SERVICE BULLETIN

from: TRIO-KENWOOD COMMUNICATIONS, INC.

SUBJECT: SERVICE NOTES ON TS-820

SUBJECT: TS-820 RIT Modification

SUBJECT: Microphone input attenuator for TS-820 DATE 2/16/77

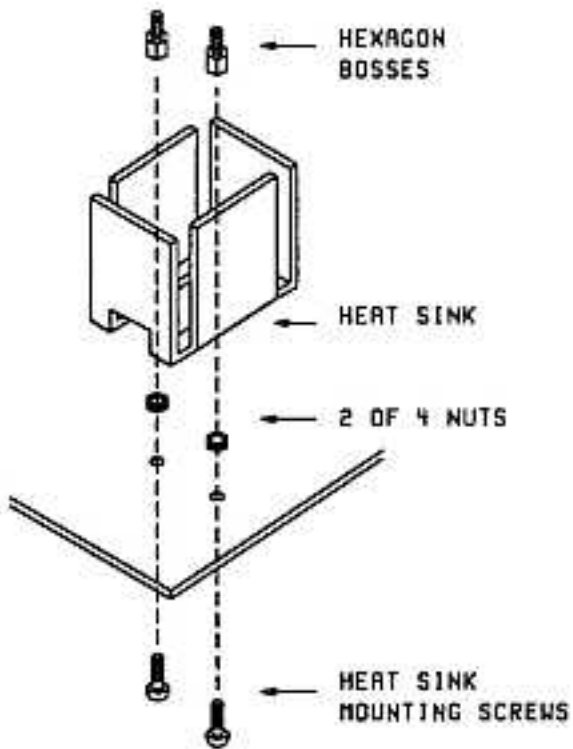
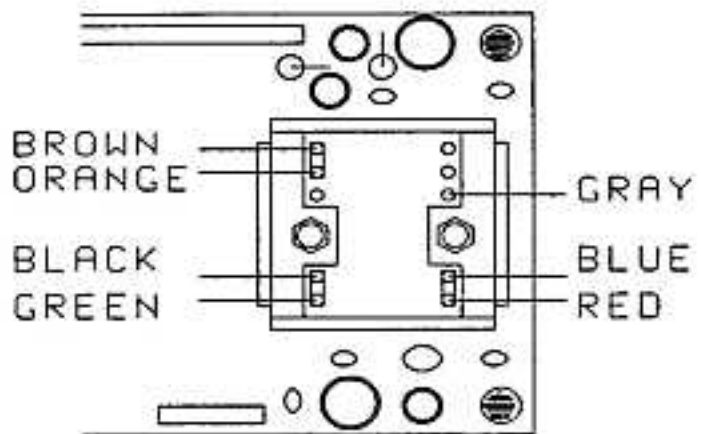
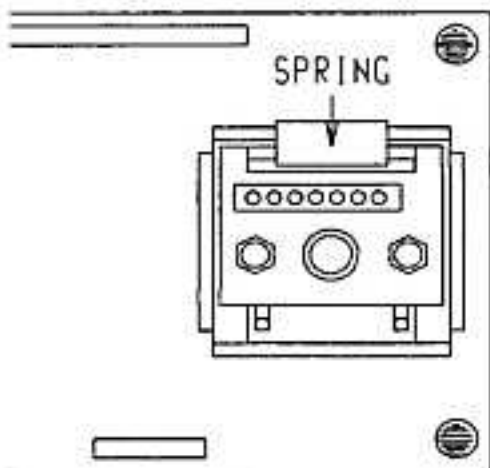
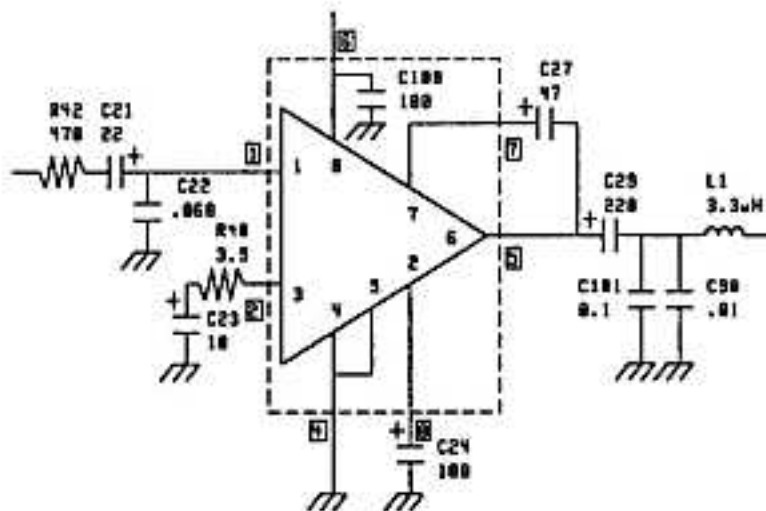
When using a high output microphone (i.e. Shure 444), it is very likely that there will be distortion of the transmitted audio if the processor is used. The reason the distortion occurs is because the processor is between the first microphone amplifier and the microphone gain control. The installation of one of the attenuators shown below will reduce the microphone input to a level that will not cause RF speech processor distortion. The attenuator figures are approximate.

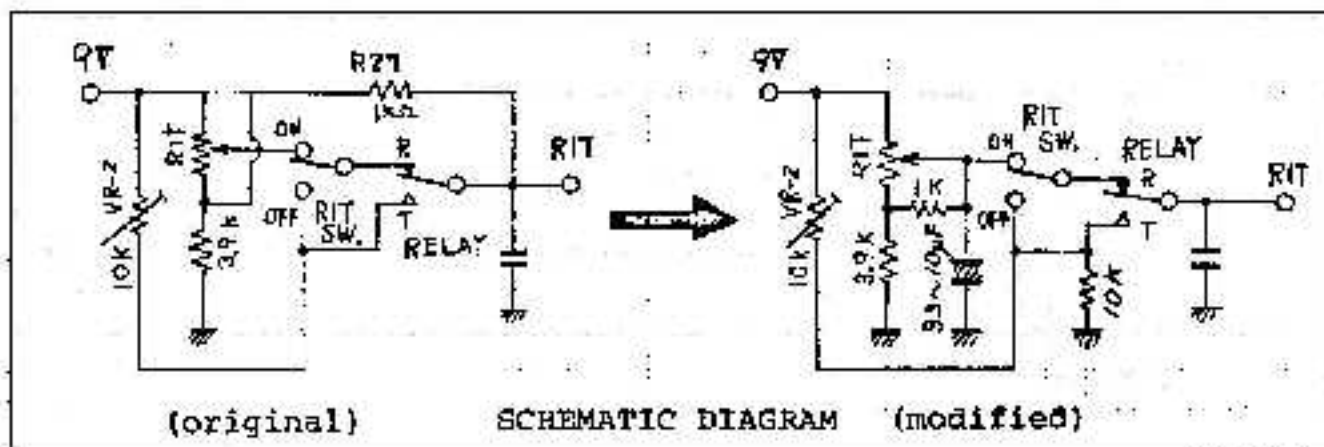
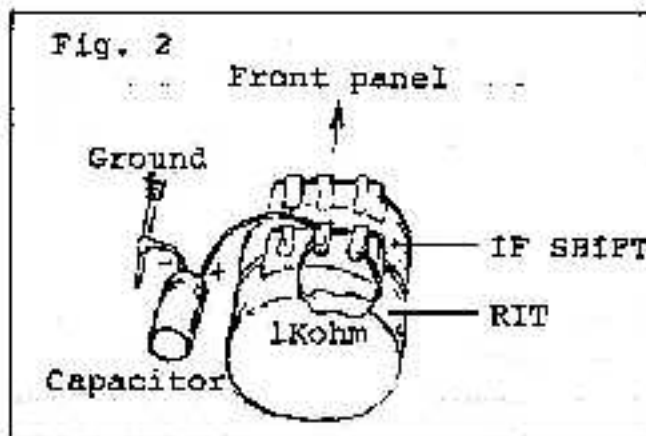
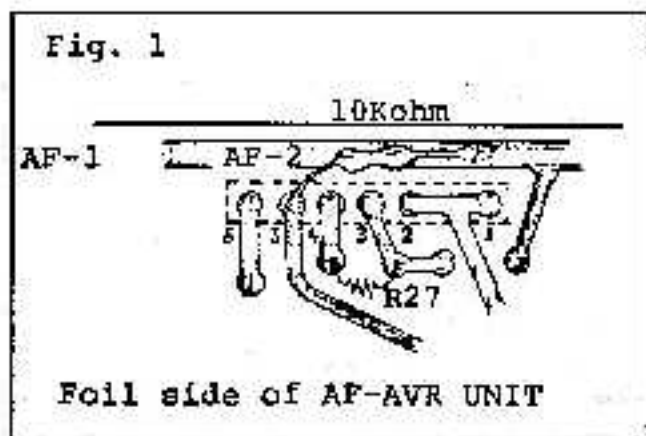
We have had a few reports of the TS-820 RIT tuning being "rubbery". The following information will solve this.

1. Remove resistor R27 (1Kohm) on AF-AVR UNIT (X49-1080-00).
2. Install a 10Kohm resistor on foil side of AF-AVR UNIT --- see Figure 1.
3. Install a 1Kohm resistor on RIT control --- see Figure 2.
4. Install a capacitor (3.3 μ F-10 μ F) between RIT control and ground --- see Figure 2.
5. Adjust VR-2 on AF-AVR UNIT (X49-1080-00) for the same frequency as the center position of the RIT control.
